# 7ELEVEN AT WALLBROOK (LOT 11)

## SITE DEVELOPMENT PLAN

**7ELEVEN AT WALLBROOK (LOT 11)**  
Town of Rolesville Project No. SDP 23-\_\_\_\_  
US 401 Business / S. Main Street & Virginia Water Drive  
Wake Forest Township, Town of Rolesville, Wake County, North Carolina

**Final Drawing - Issued for Permit Review Purposes Only**

Date: May 2023

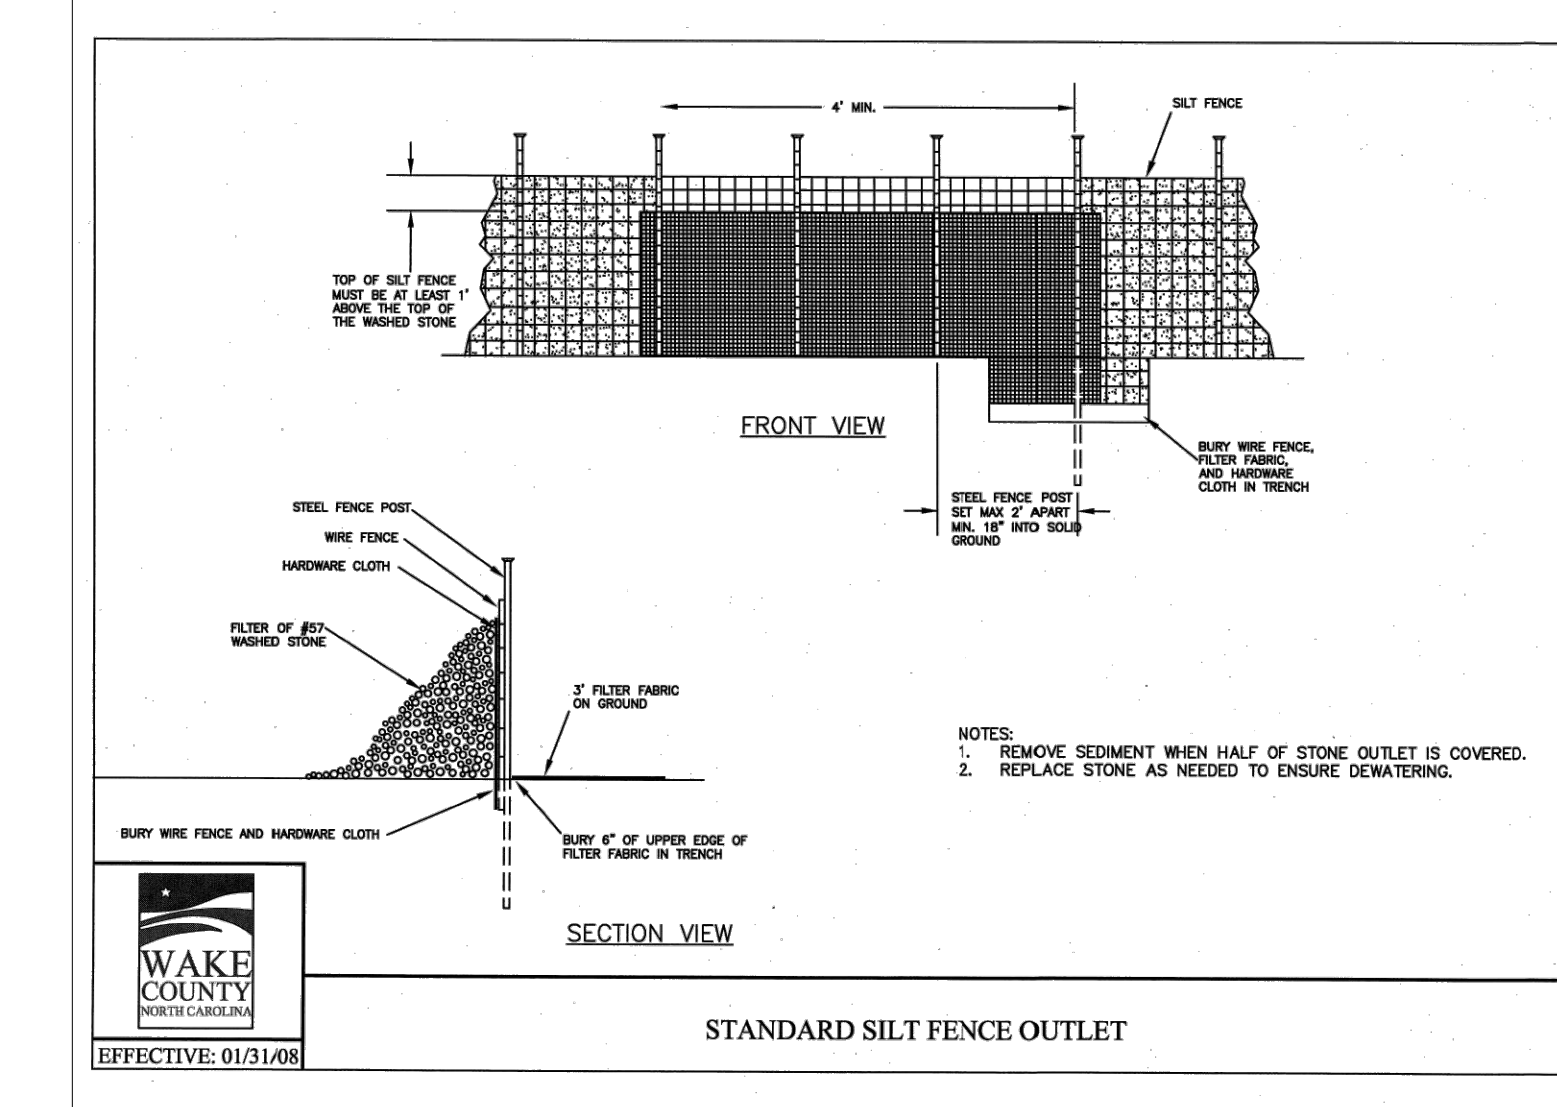
Clarify which CID this is referring to.

Label tree protection fencing and critical root zone of any trees to be preserved.

**C2.0**  
Date: May 2023

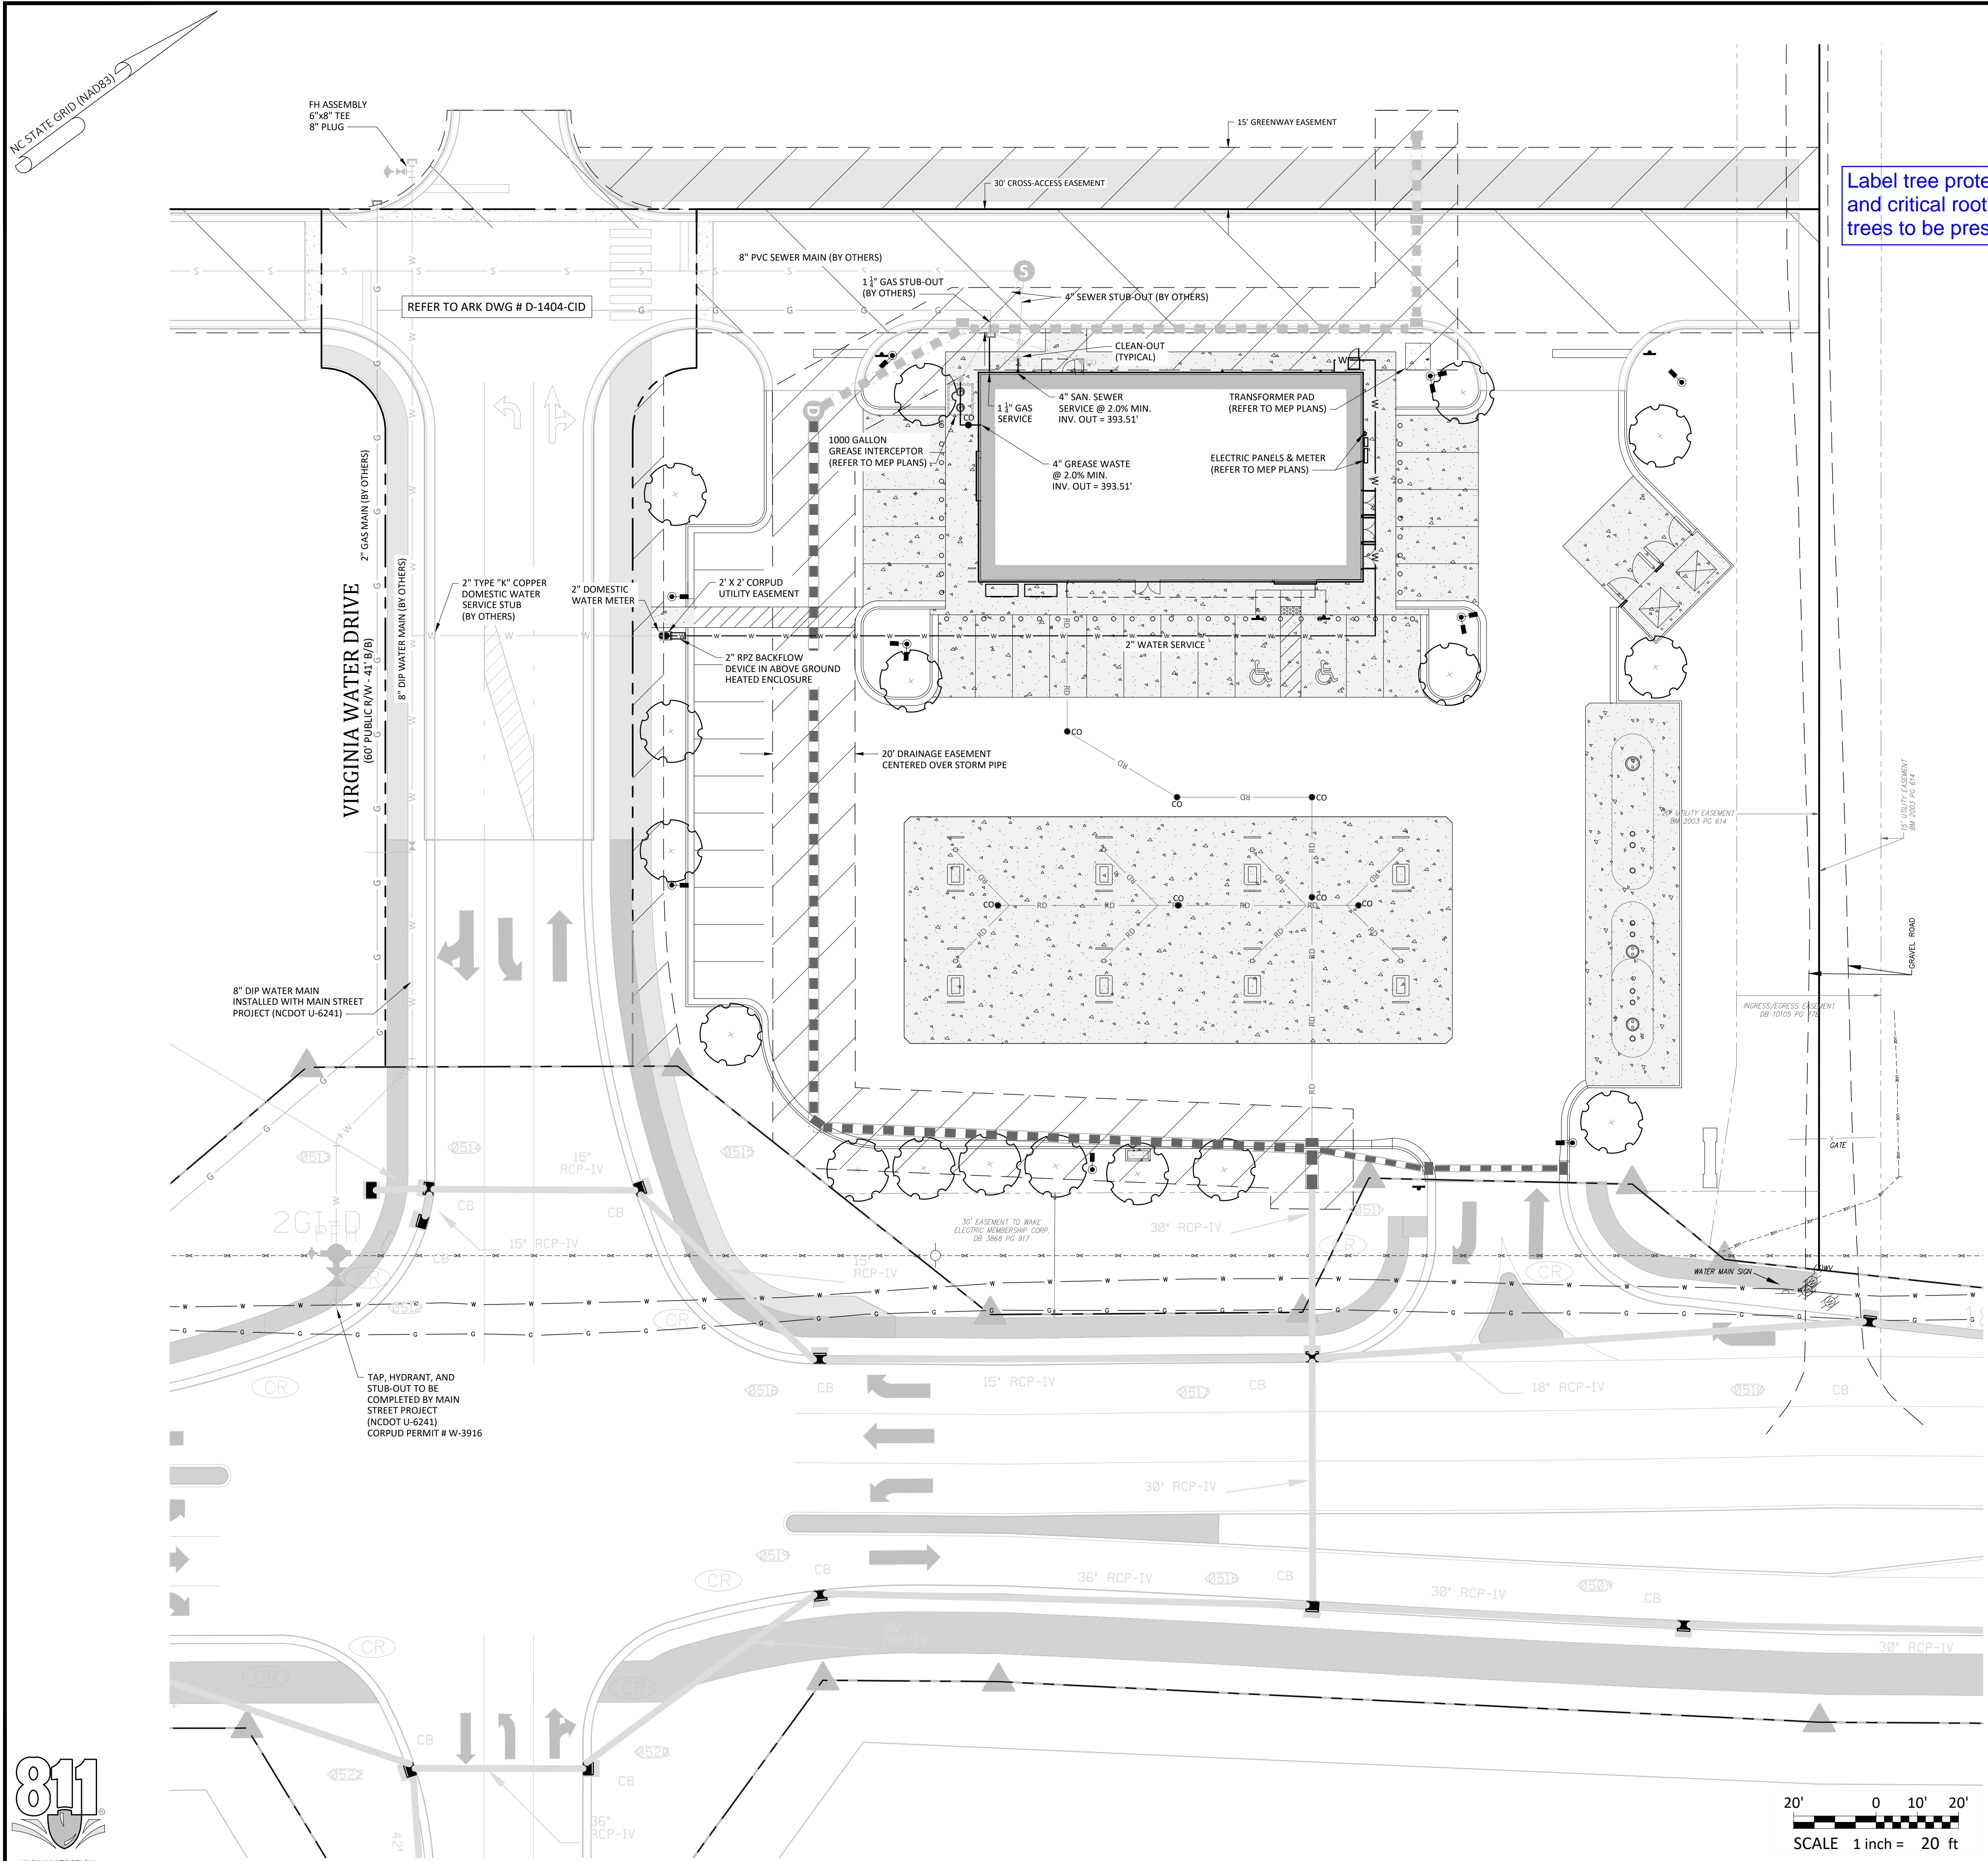
Label tree protection fencing and critical root zone of any trees to be preserved.

Provide a legend or key of what symbols mean.

**REQUIRED VEGETATION PLAN**

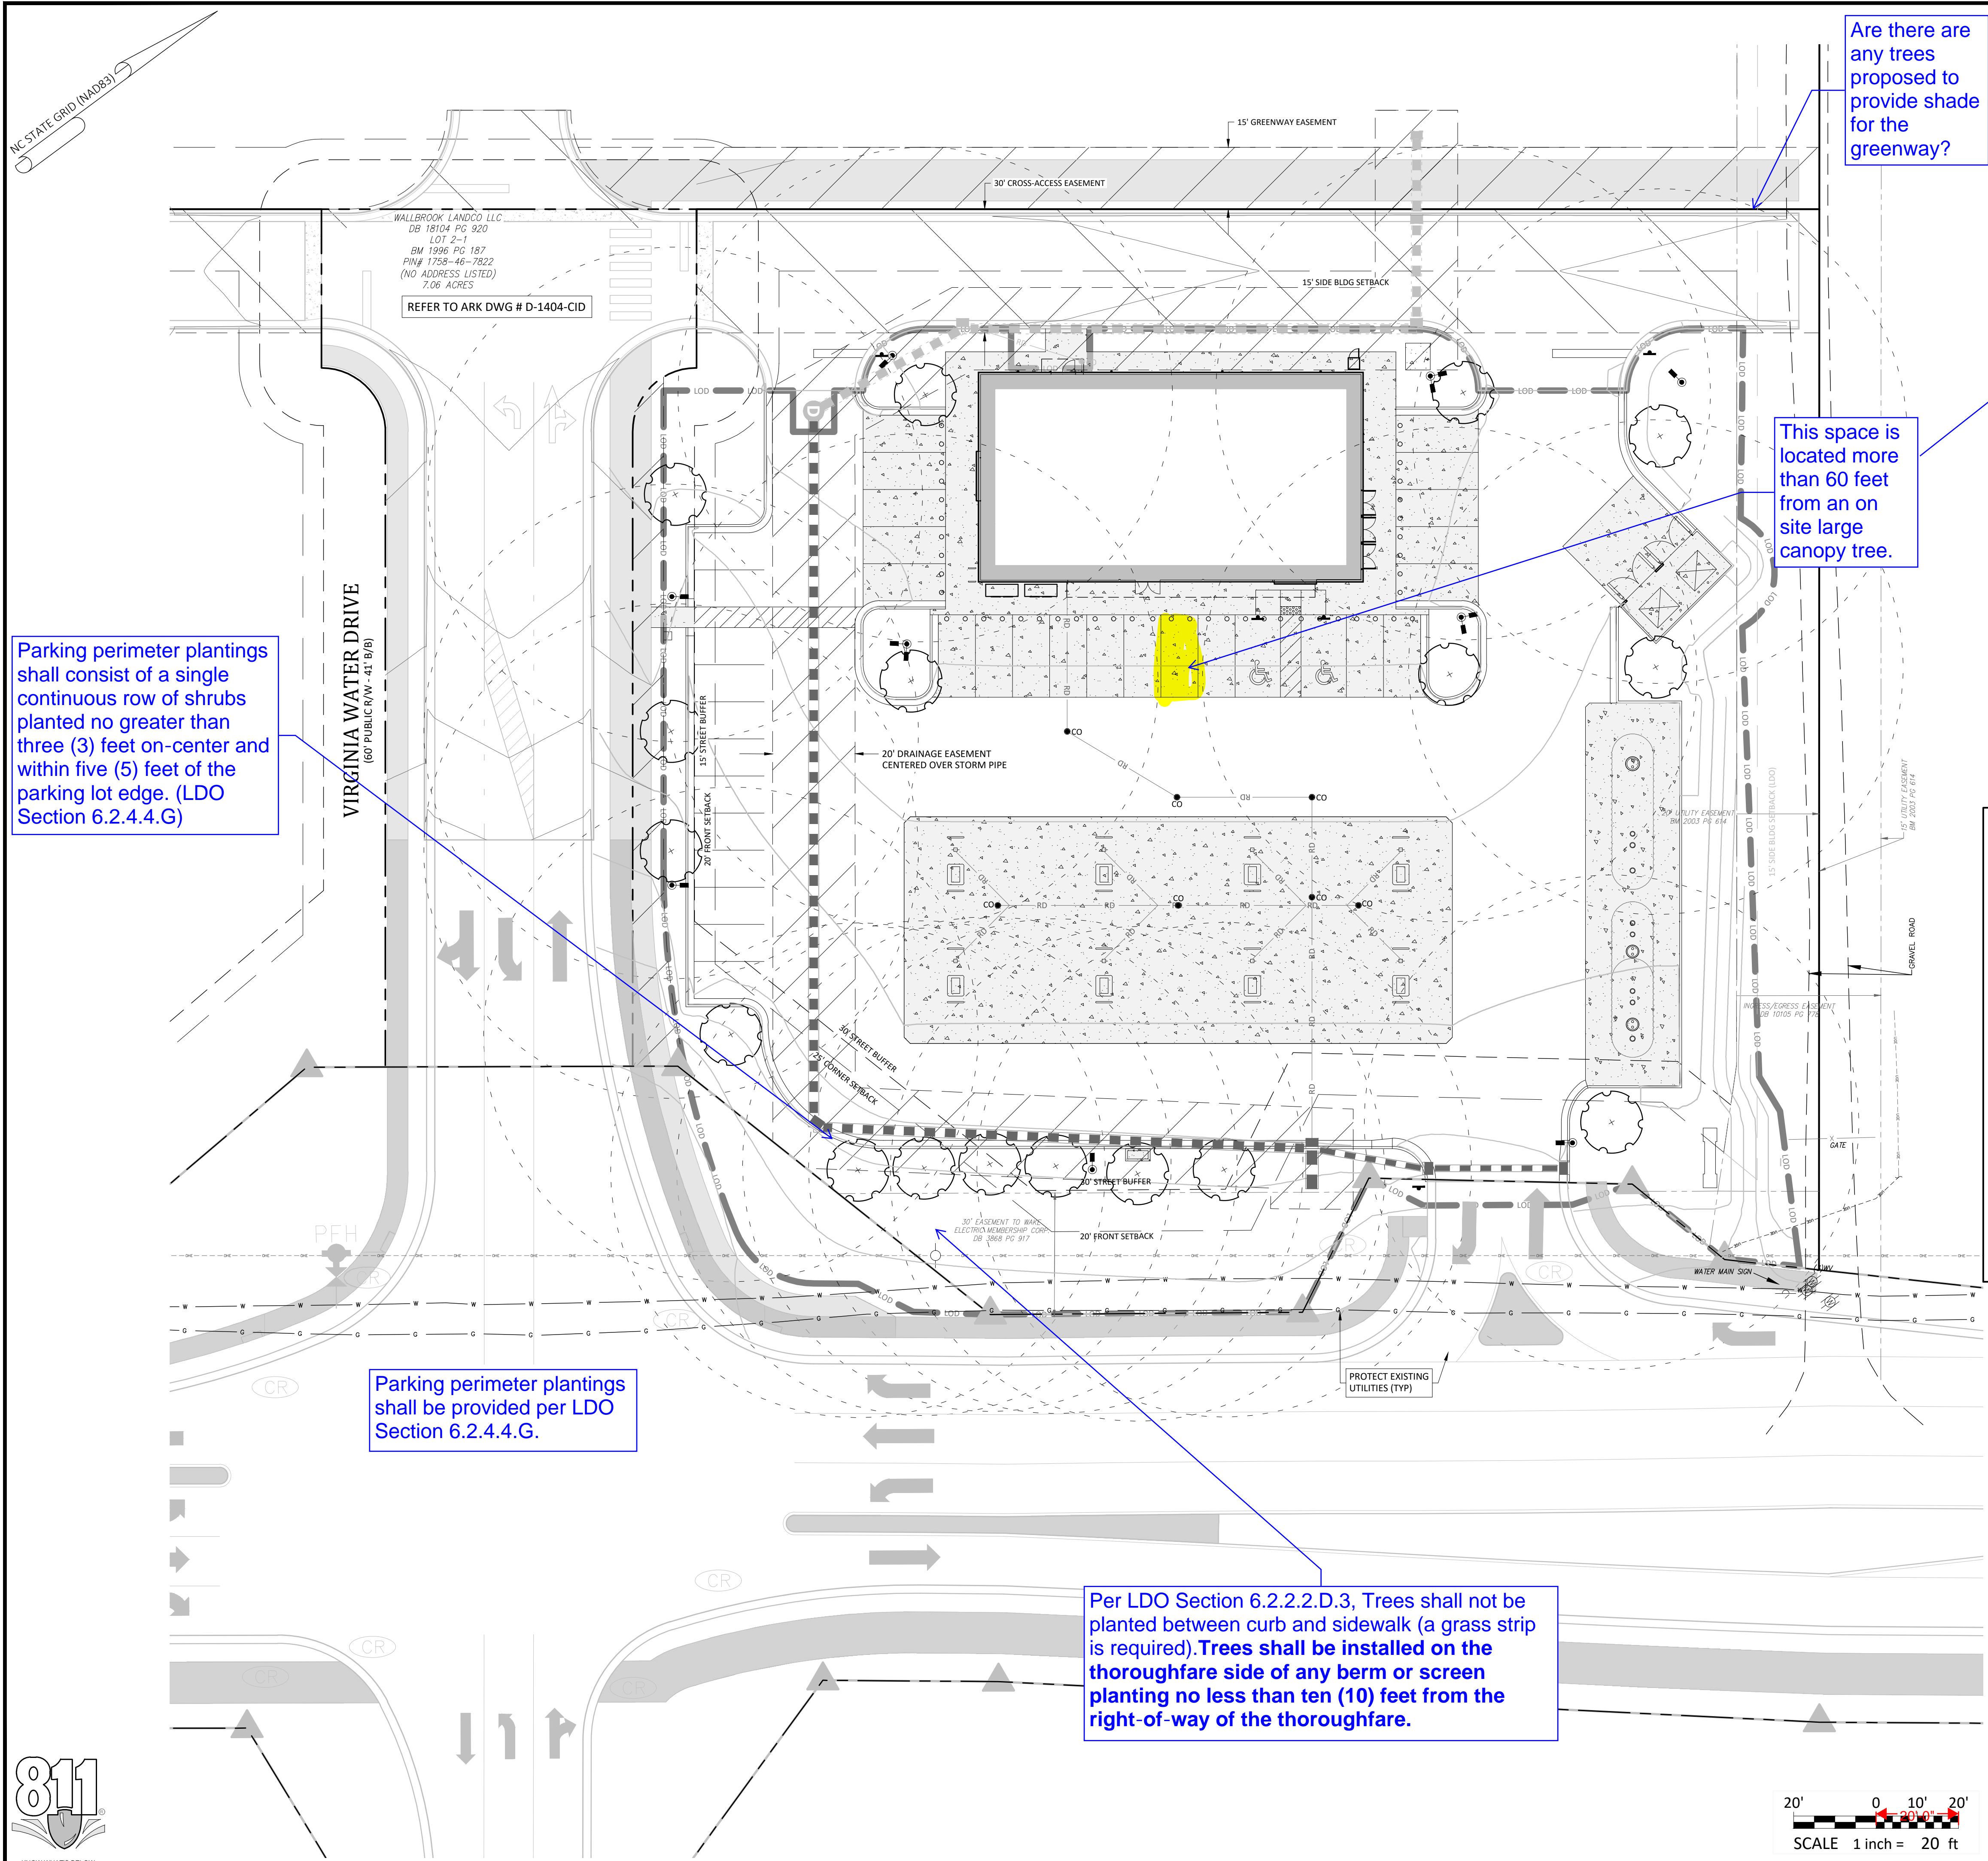
Label location of shrubs as well as provide a total count.

Parking perimeter plantings shall consist of a single continuous row of shrubs planted no greater than three (3) feet on-center and within five (5) feet of the parking lot edge. (LDO Section 6.2.4.4.G)

Parking perimeter plantings shall be provided per LDO Section 6.2.4.4.G.

Per LDO Section 6.2.2.D.3, Trees shall not be planted between curb and sidewalk (a grass strip is required). Trees shall be installed on the thoroughfare side of any berm or screen planting no less than ten (10) feet from the right-of-way of the thoroughfare.

Are there any trees proposed to provide shade for the greenway?
